3.5 inch LED Door Station V2.2.32_221212 Release Note (2022-12-20)

Device Model	DS-KD3003-E6、 DS-KD8103-E6、 DS-KD8023-E6
Firmware Version	V2.2.32_221212
iVMS-4200 Version	Late version
Hik-Connect APP	Late version

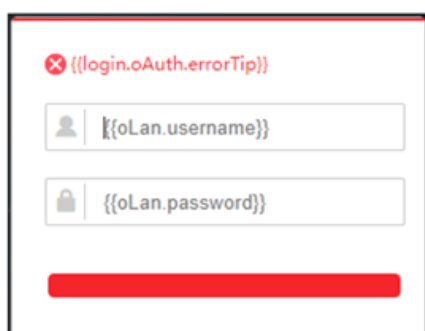
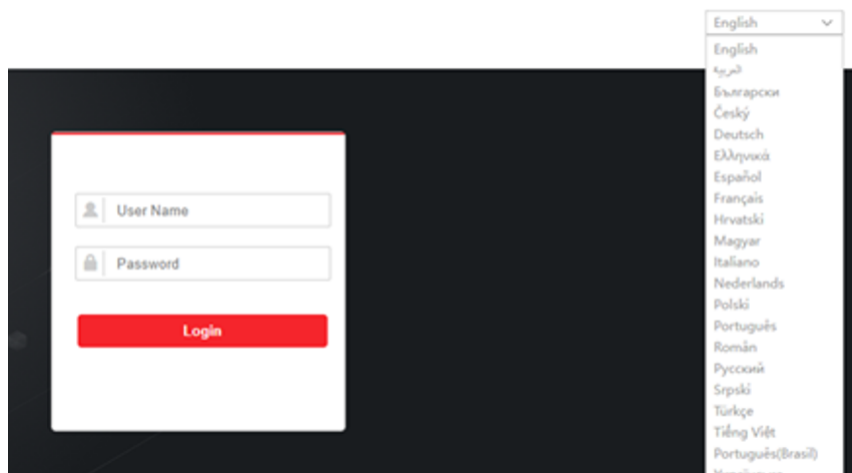
1. it's a temporary firmware, solved issue, we will release baseline firmware soon
2. when select different language (English in default)from web login interface, cannot login the device, same as below
